**Bellefonte Evacuation Time Estimate Report**

**Supplement 1**

## Bellefonte Evacuation Time Estimate

**Figure E-3. Major Employers within the BLN EPZ**

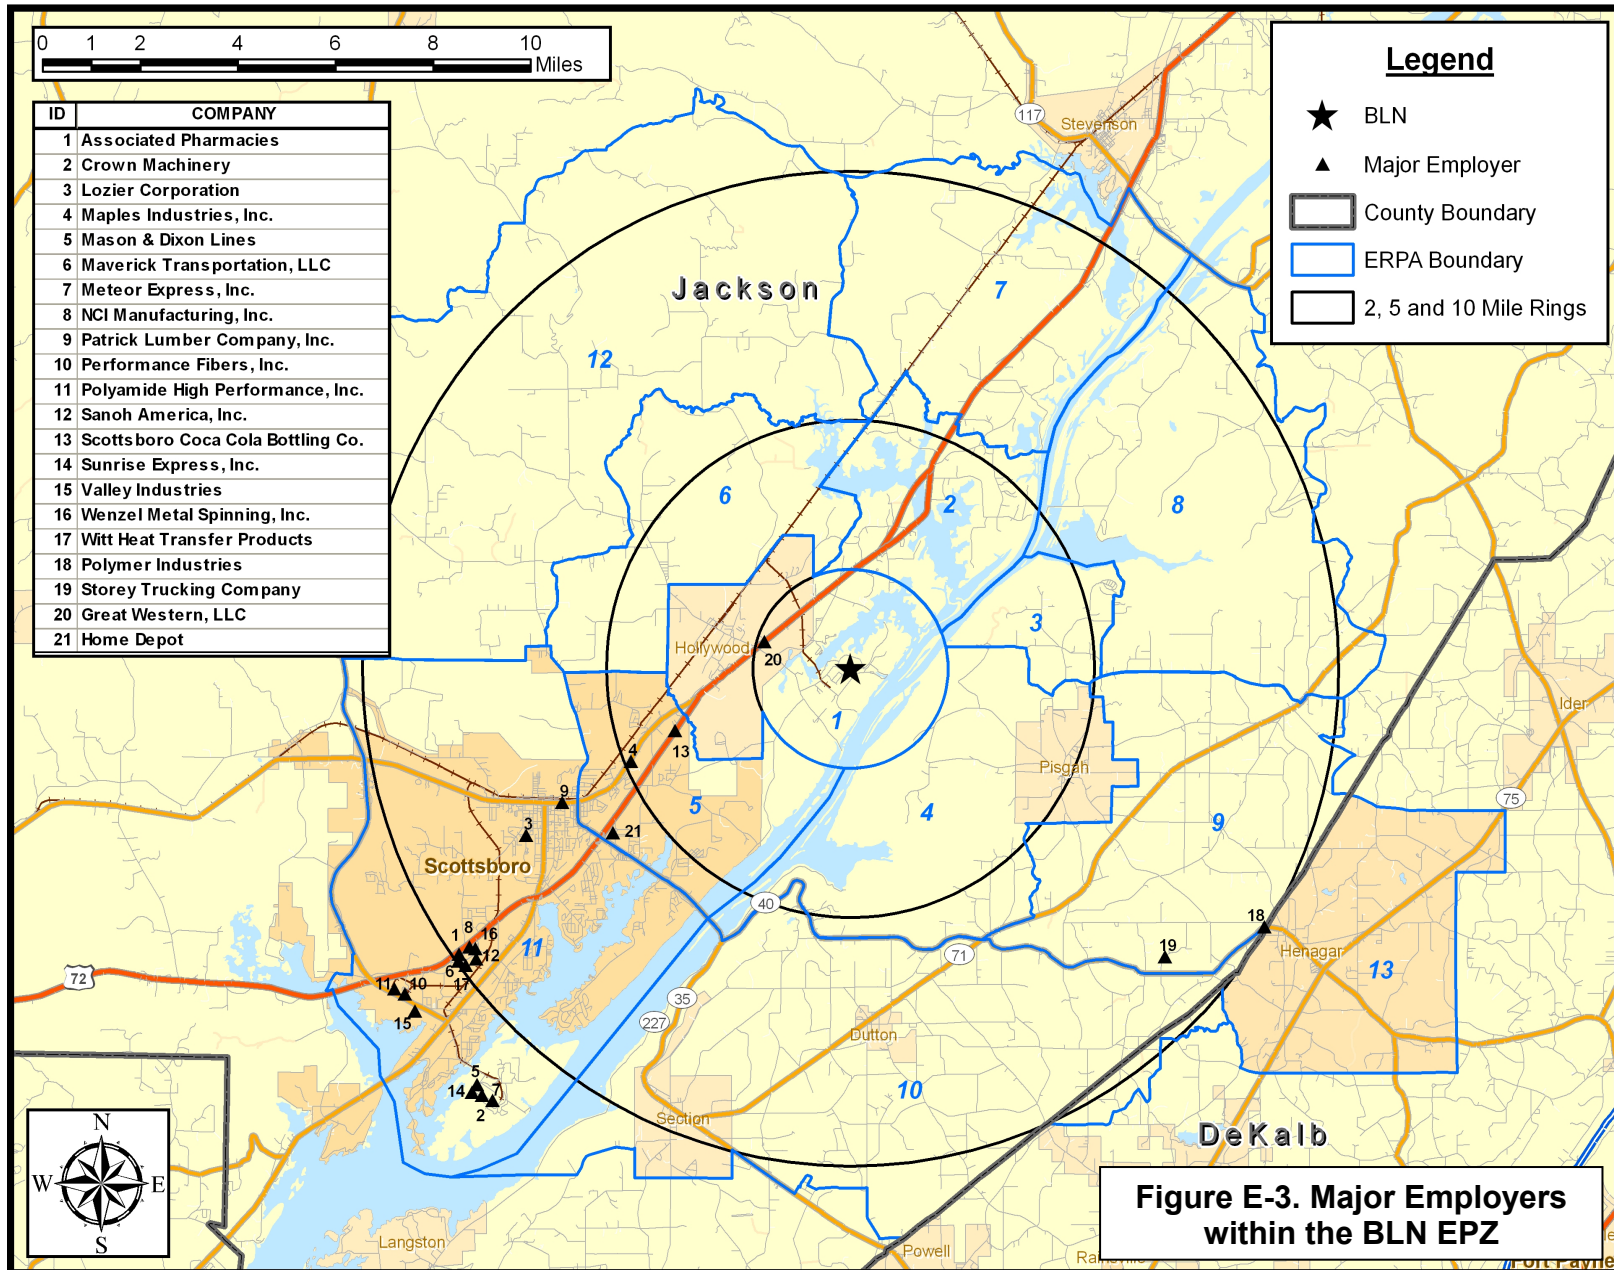
- Supplemented by adding Figure E-3, a GIS map of all major employers within the BLN EPZ. See supplemental figure provided in this Errata Sheet.

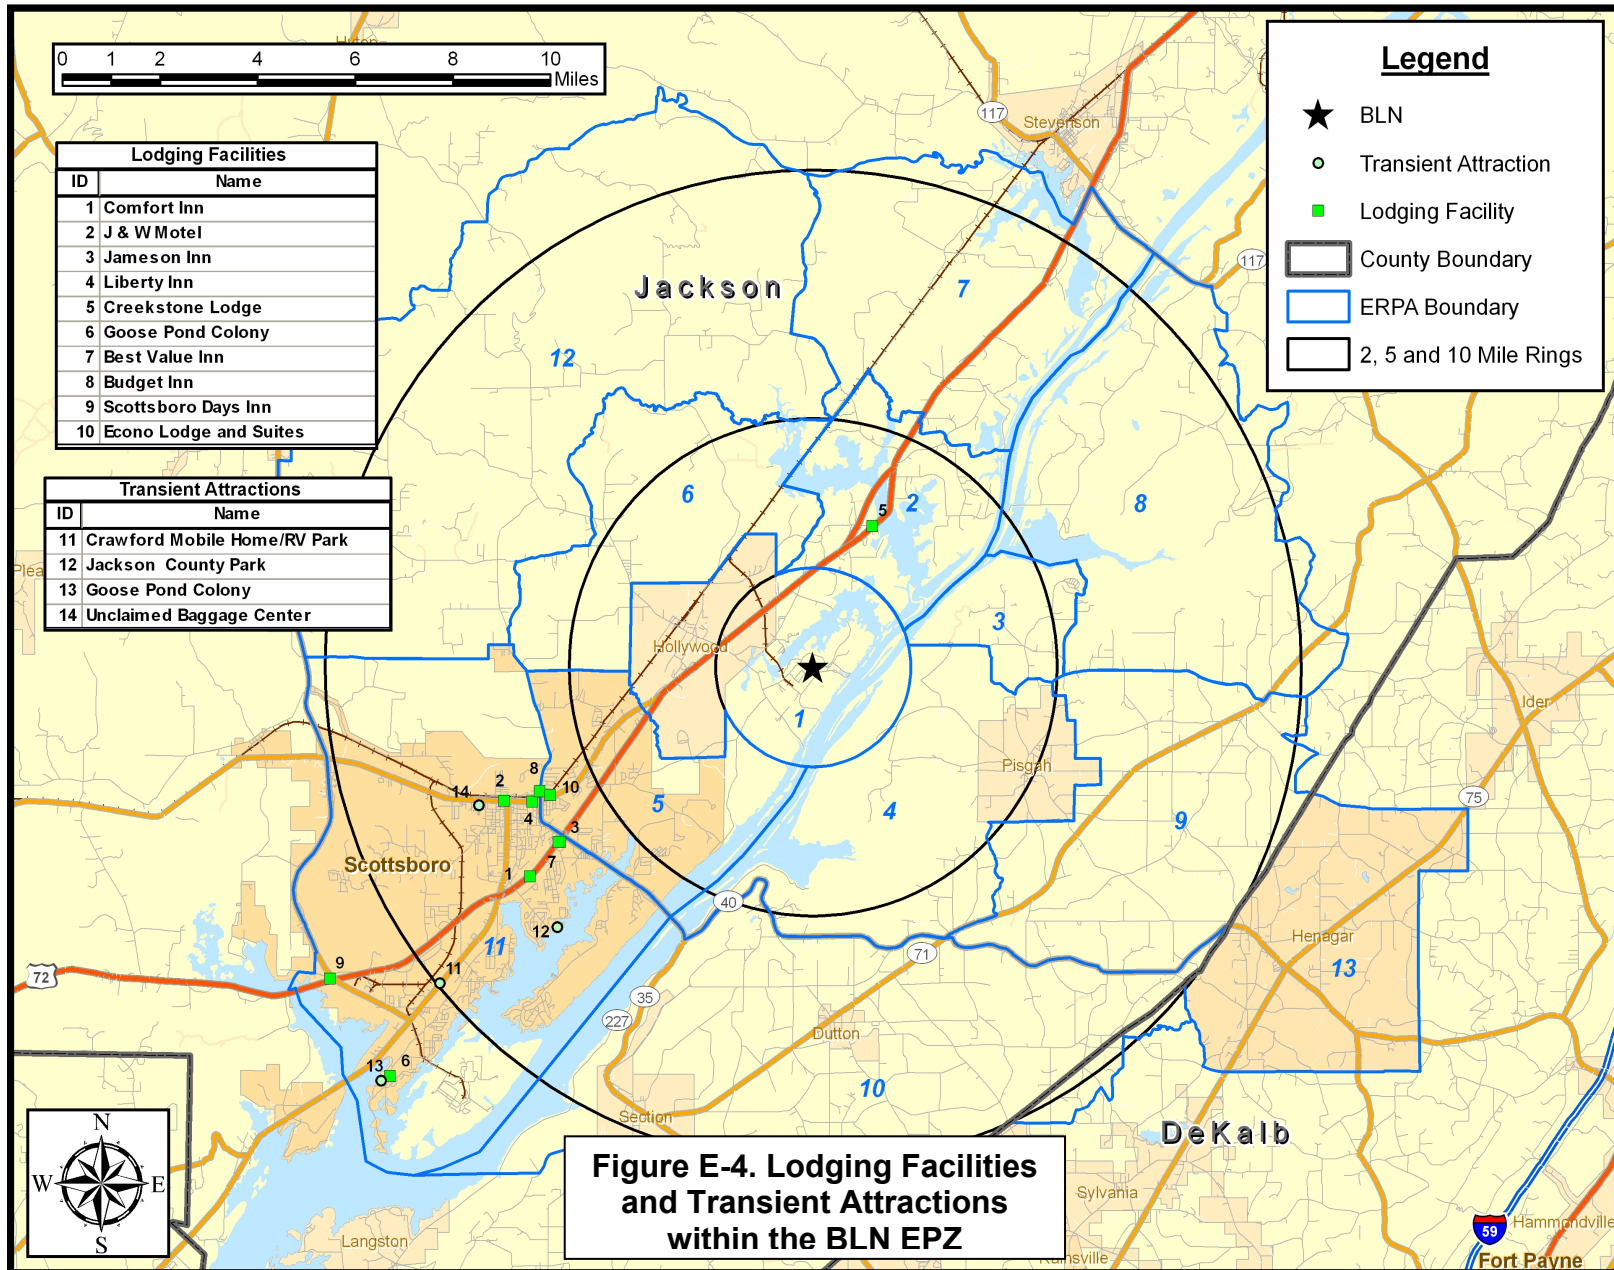
- Supplemented by adding Added Figure E-4, a GIS map of all lodging facilities and transient attractions within the BLN EPZ. See supplemental figure provided in this Errata Sheet.
